RE: Medal of Honor – Site and Lighting Improvements

Project #PR-001-23

Date: April 22, 2024

This Addendum forms a part of, and modifies, the Bid Documents for the above referenced project, dated March 25. 2024. Acknowledge the receipt of this Addendum No. 2 in the space provided on the Bid Form. Failure to do so may subject Bidder to disqualification.

E2.2

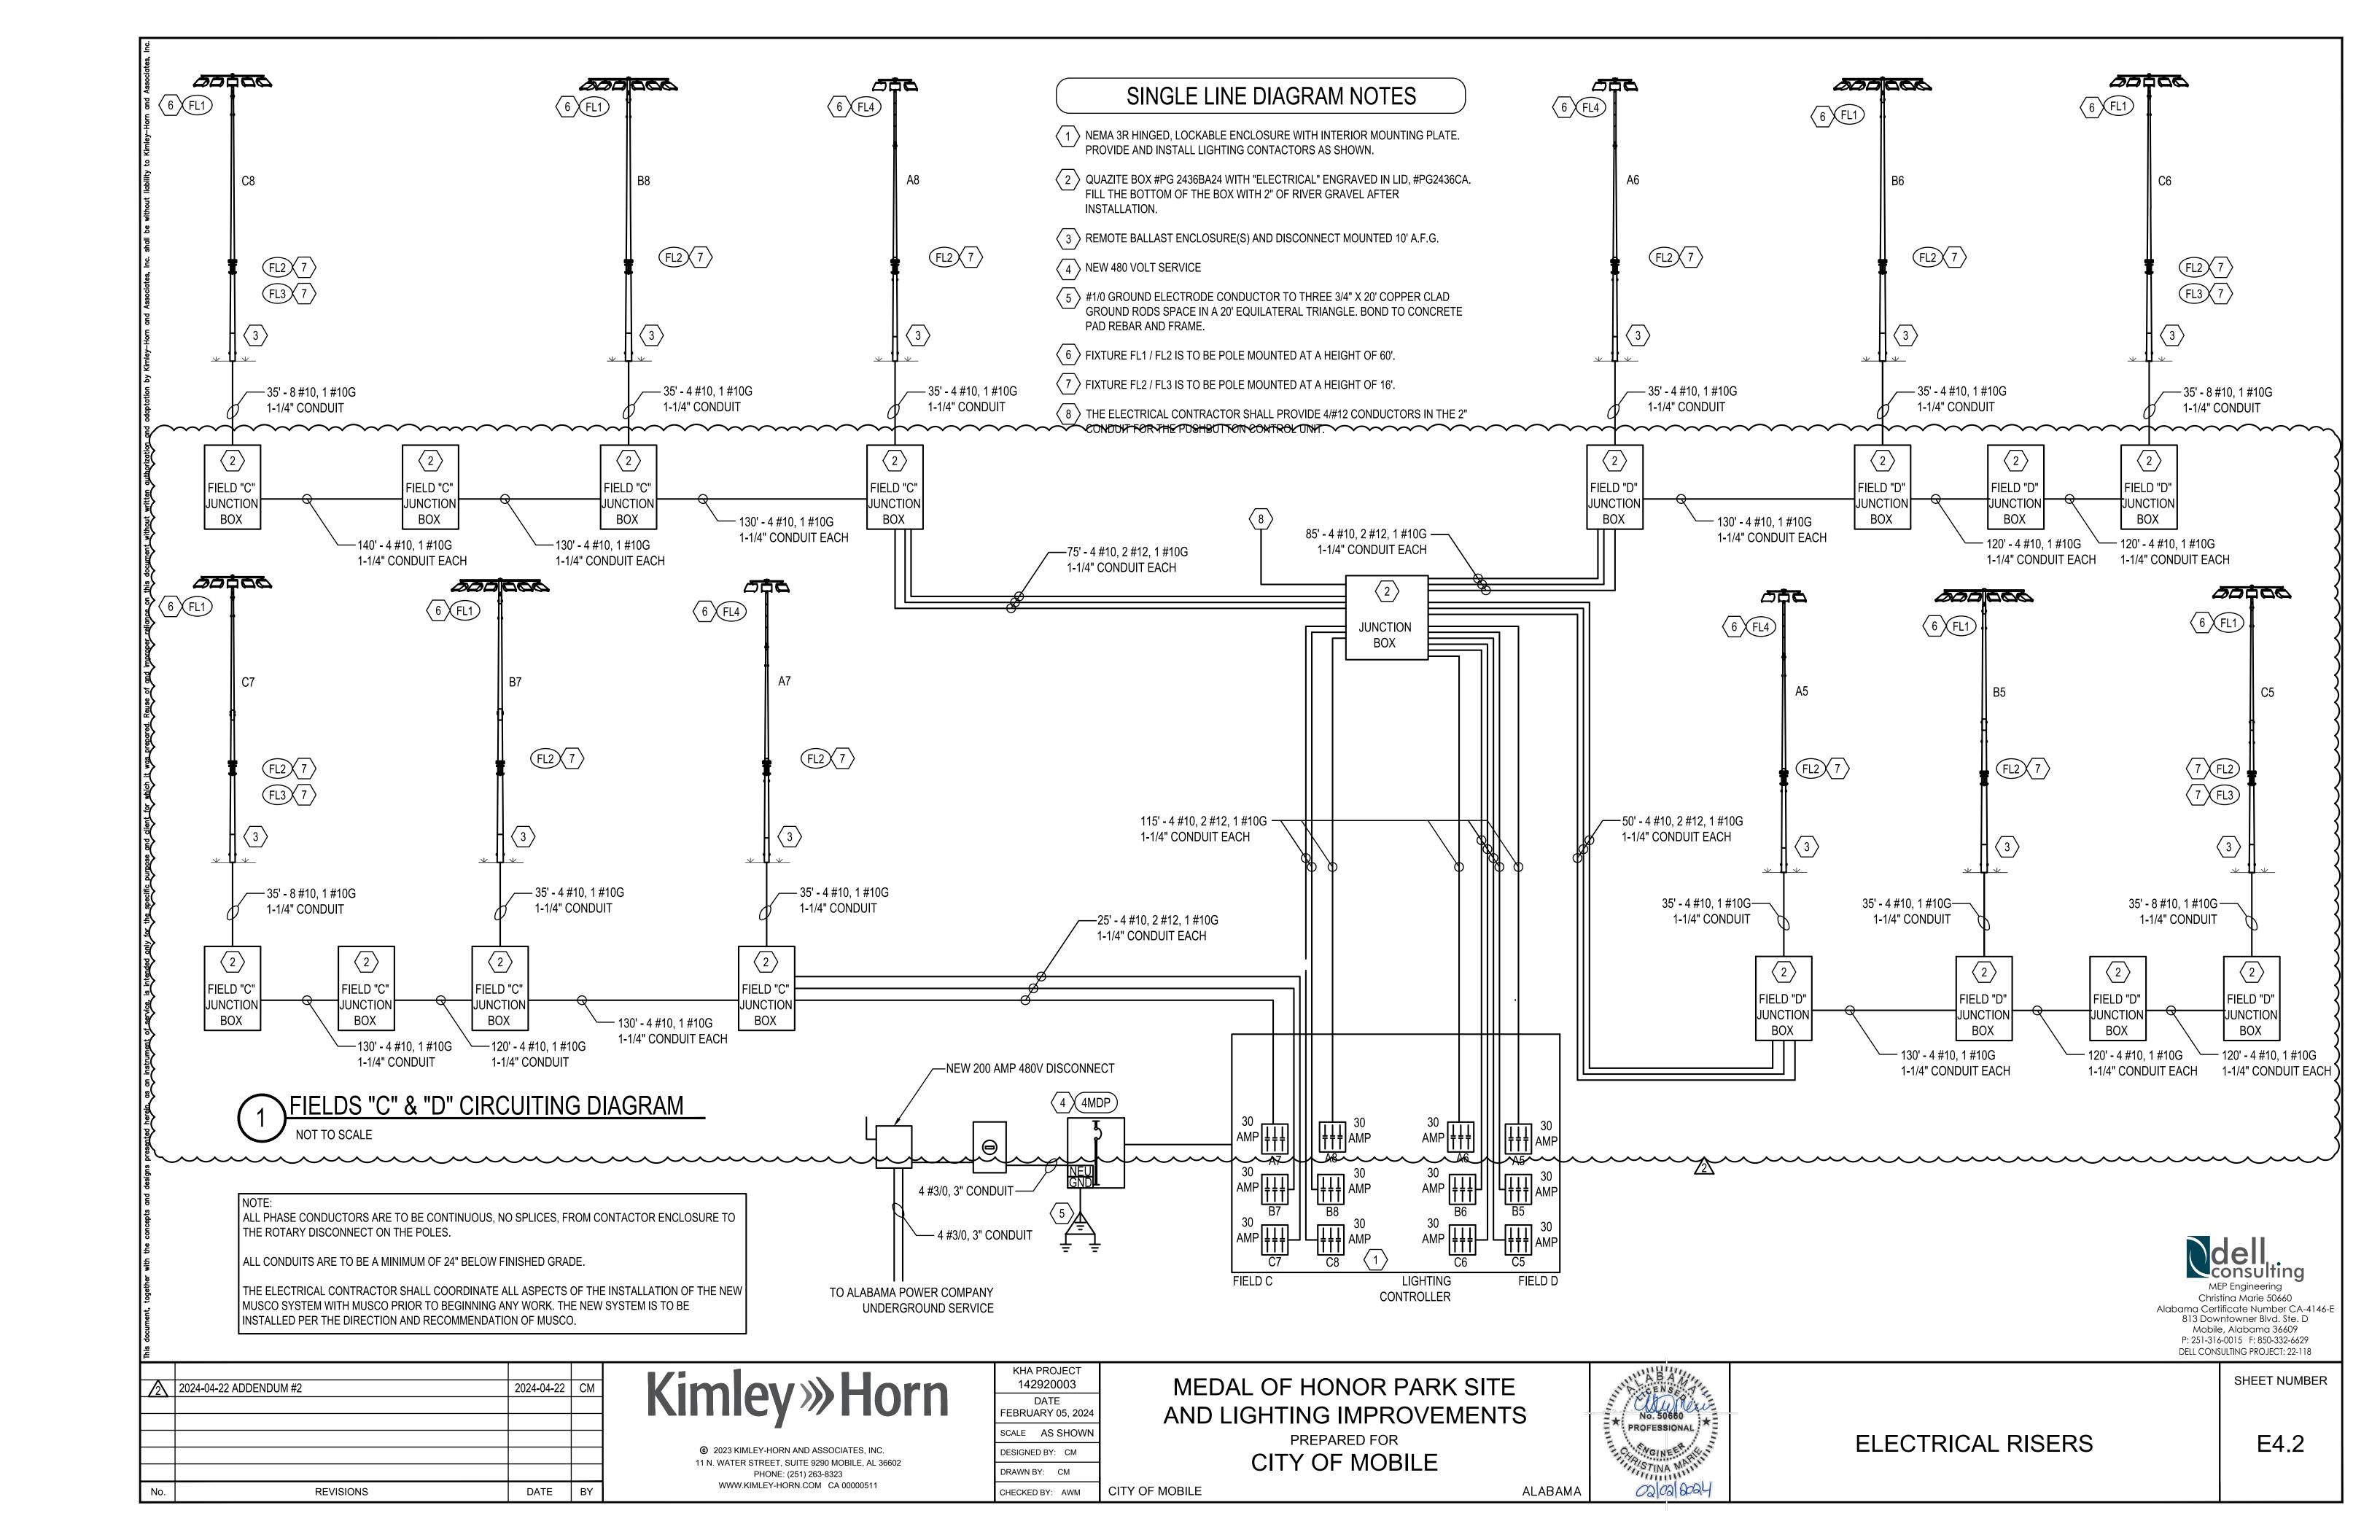
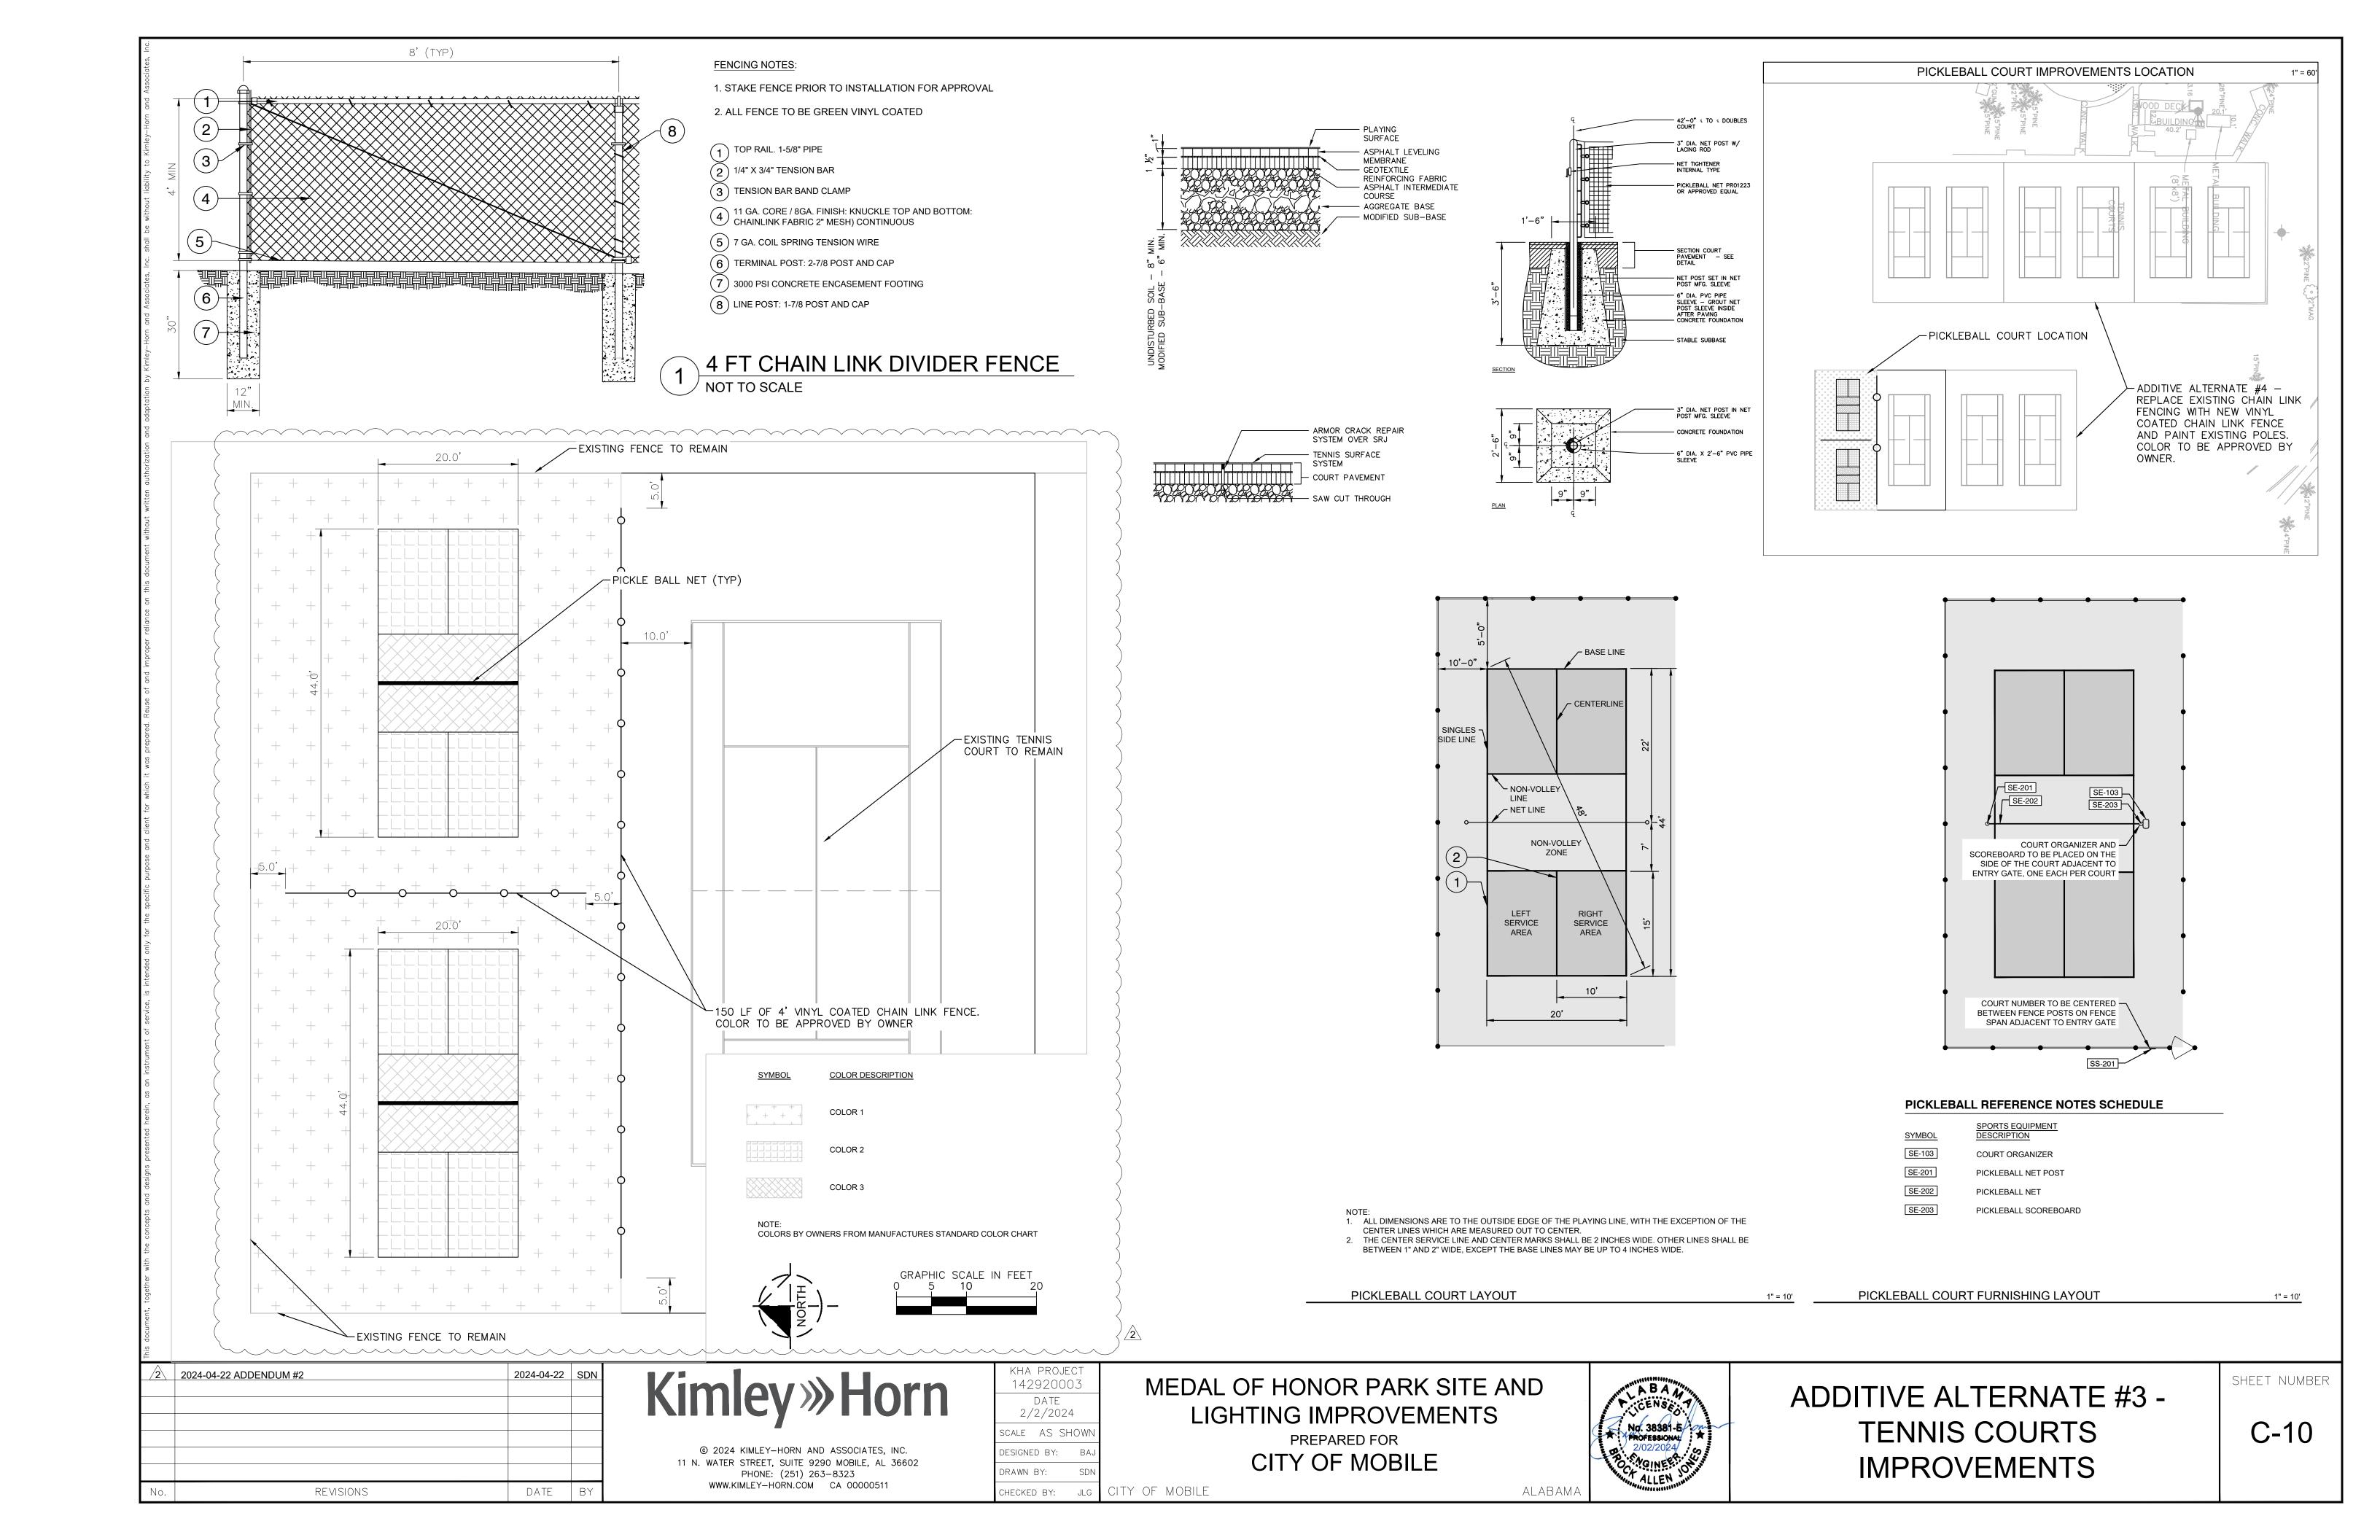
- 1. Currently the tennis courts have two pole light configurations that will be modified as follows:
 - 1.1.All poles have pole top luminaries that will be removed and replaced new per new work plans (including all hardware, brackets, etc.).
 - 1.2.shared poles (between the tennis courts) also have luminaries that are mounted below the pole top luminaries that will be completely removed. the openings in the pole are to be provided with a watertight blank plate.
- 2. The original contract documents showed a dedicated circuit for the RGBW fixtures for each field, after further conversation with MUSCO, that circuit can be eliminated and the RGBW fixtures can be served from the field lighting circuit serving the associated pole.

- 1. CURRENTLY THE TENNIS COURTS HAVE TWO POLE LIGHT CONFIGURATIONS THAT WILL BE MODIFIED AS FOLLOWS:
- 1.1. ALL POLES HAVE POLE TOP LUMINARIES THAT WILL BE REMOVED AND REPLACED NEW PER NEW WORK PLANS (INCLUDING ALL HARDWARE, BRACKETS, ETC.).
- 1.2. SHARED POLES (BETWEEN THE TENNIS COURTS) ALSO HAVE LUMINARIES THAT ARE MOUNTED BELOW THE POLE TOP LUMINARIES THAT WILL BE COMPLETELY REMOVED. THE OPENINGS IN THE POLE ARE TO BE PROVIDED WITH A WATERTIGHT BLANK PLATE.
